Our ref: PS214031-WSP-SYD-CIV-LTR-001 Rev1.docx

105 Miller Street Response to SSD submissions - Flooding

This letter has been prepared in response to agency advice for the SSD submission (SSD-83956216) for the redevelopment and adaptive reuse of the building at 105 Miller Street, North Sydney. It responds to issues raised by Heritage Council, Conservation Programs, Heritage and Regulation (CPHR) Group and NSW State Emergency Services.

Figure 1 Flood mitigation Option 1

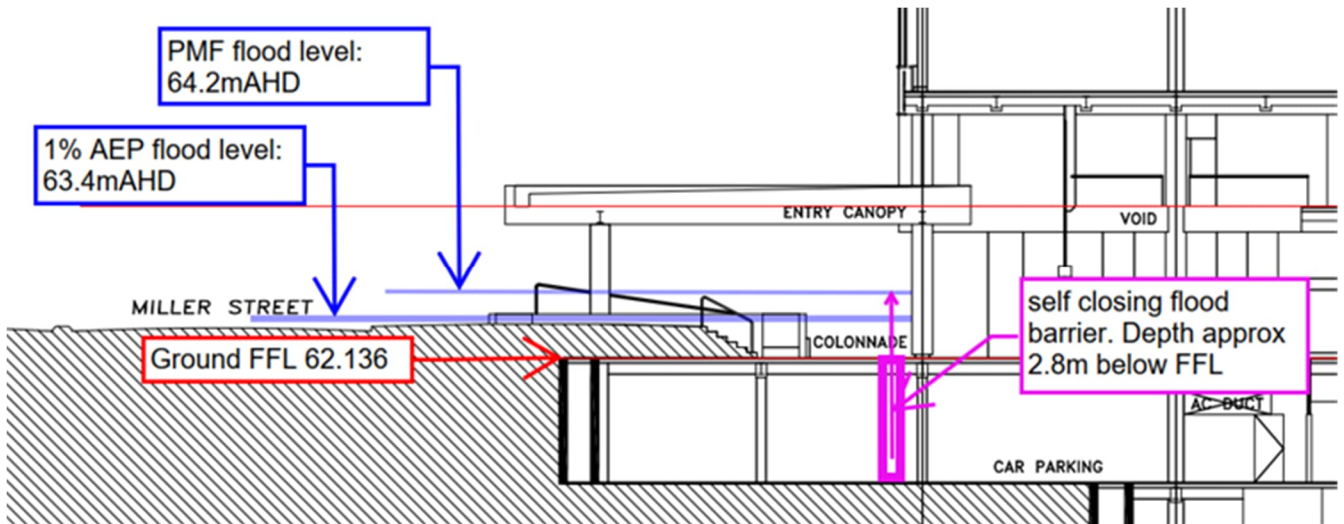
4. Proposed flood alleviation

The Heritage Council acknowledges the issue of stormwater flooding on Miller Street but is concerned about the heritage impacts that would result from the SSD's proposed flood alleviation strategy. The Heritage Council's (April 2025) pre-lodgement advice was that alternative options should be considered to alleviate flooding without raising the Miller Street ground floor level. The scheme remains unchanged from pre-lodgement.

Option 1 – self raising flood barrier at ground floor. This would involve installing a flood barrier at the lobby entry, and flood proof glazing (or other flood proof treatment) along the ground floor colonnade. This option was considered to have an unacceptable impact on the basement below.

Figure 5 DRAINS inlet capacity calculator

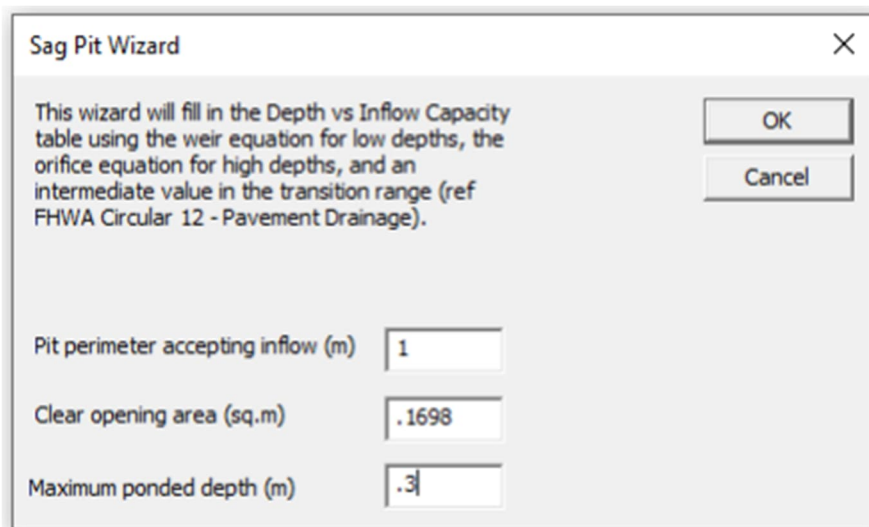
Modelling of the flood storage tank should ensure that inlet capacity of the grated drain is correctly accounted for. The flood model is to be updated to include blockage of the proposed grated drain (50%) and allow for multiple entry points. Alternative entry structures are likely to be required to ensure that flood impacts are not transferred offsite in the event of drain blockage.

In order to calculate the inflow capacity of the proposed grated drain along the Miller St boundary, we have calculated the inlet capacity of a 1m section of 300mm wide grated drain with heelsafe grate using the sag pit wizard in DRAINS. The clear opening area is based on data available from ACO for a 300mm wide heelsafe grate.

Figure 8 1% AEP flood impact

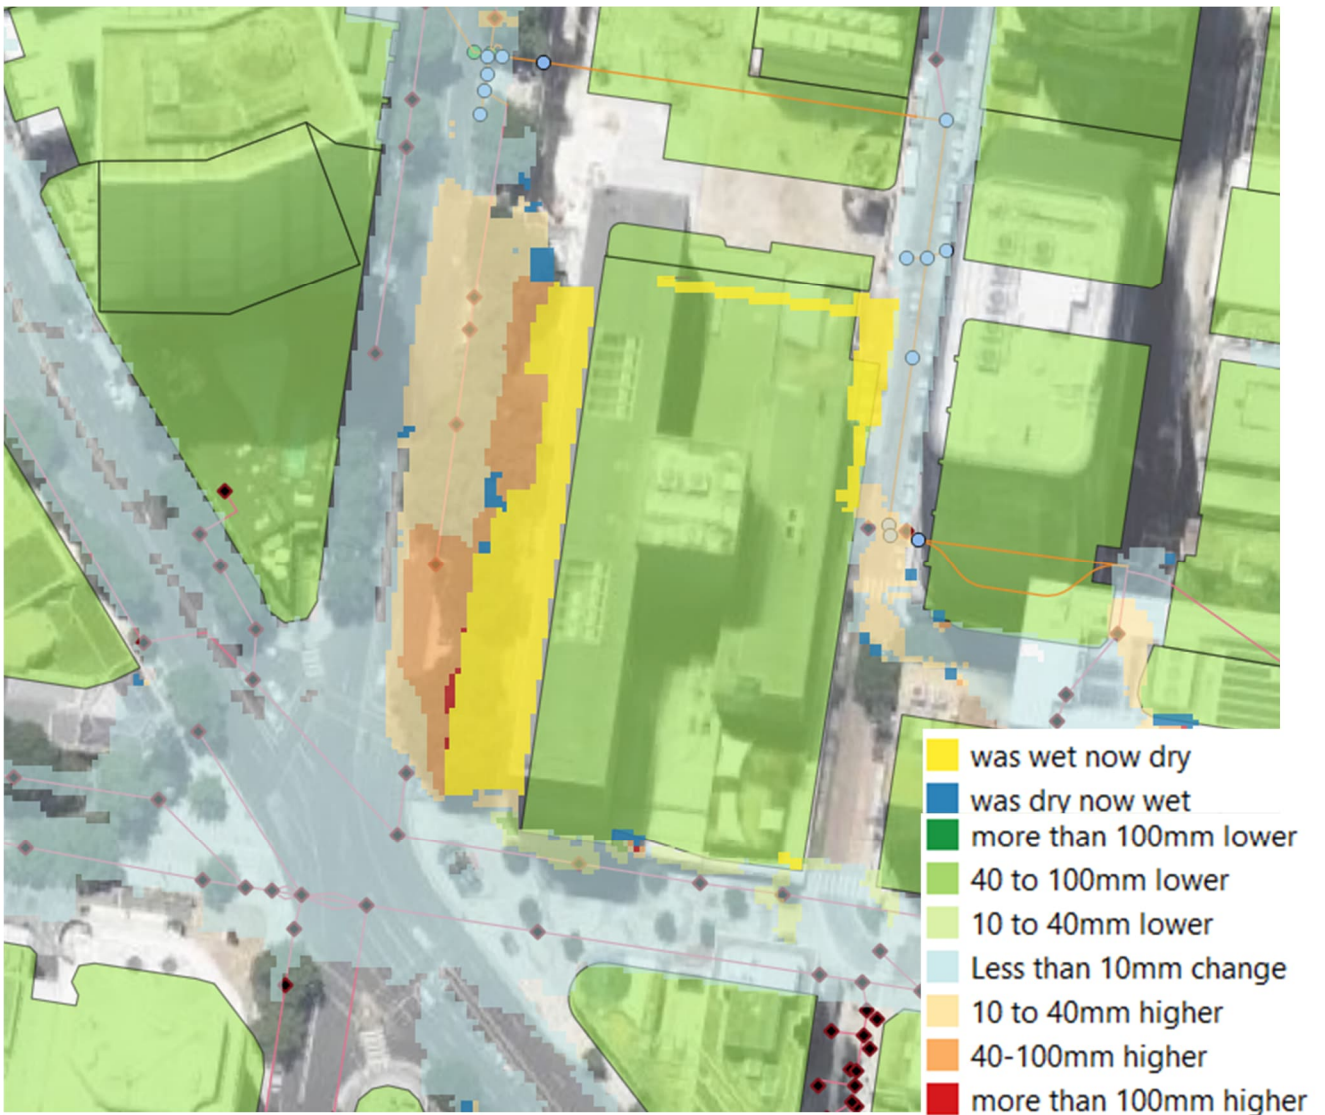
Update flood modelling to indicate further gradation of offsite impacts in excess of 10 mm. Adequate mitigation is required to be provided to ensure that existing hazard or velocity does not increase for existing flow paths and flow diversion to other offsite locations does not pose new risk.

Figure 8 below shows the flood impact at a more refined detail showing where there is more than 10mm change in flood levels.

The map shows a relatively minor impact on flood level in Miller Street, noting that this does not extend to adjacent properties.
